Subject: Grand Gulf Nuclear Station
Docket No. 50-416
License No. NPF-29
Changes to Emergency Plan Implementing Procedures – June 5, 2001

GNRO-2001/00047

10-S-01-29
Revision: 16
Date: 5/25/01

EMERGENCY PLAN PROCEDURE
OPERATIONS SUPPORT CENTER (OSC) OPERATIONS
SAFETY RELATED

10-S-01-29	Revision: 16
Attachment I	Page 1 of 2

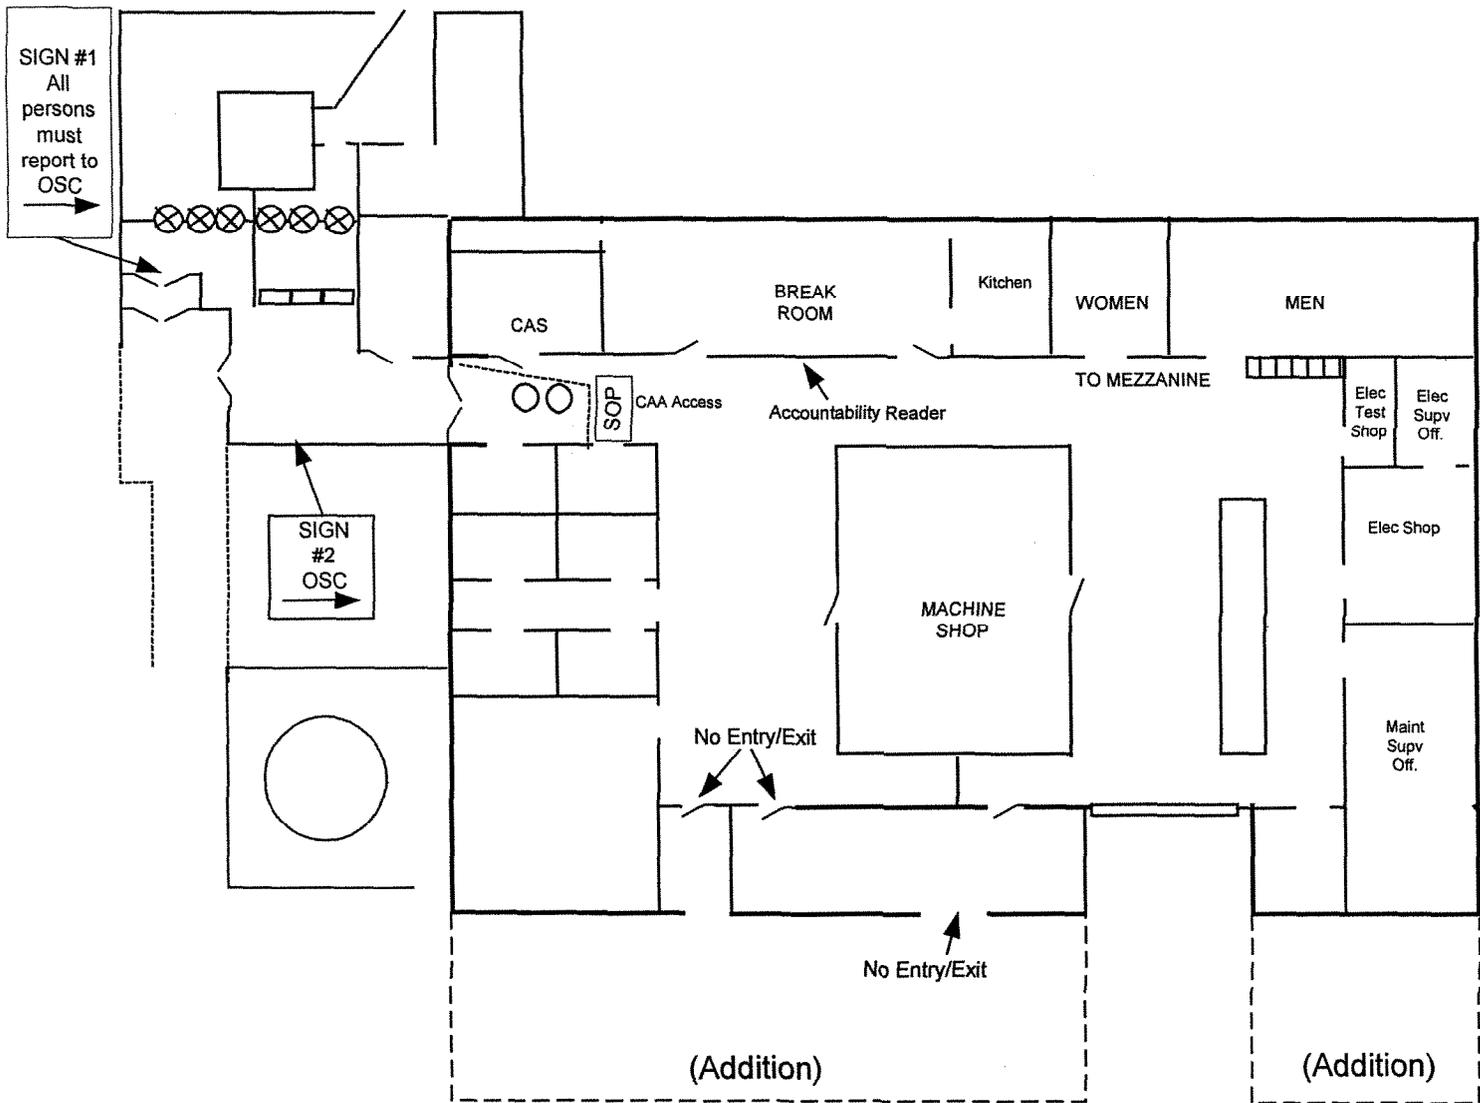
- Adds requirement for On-Shift Electrical maintenance personnel to call in additional Maintenance personnel if the required number of Maintenance personnel are not on site to support ERO staffing.
- Corrects OSC entrance instructions and layout for additions made to the Maintenance Shop.
- Grammatical changes.
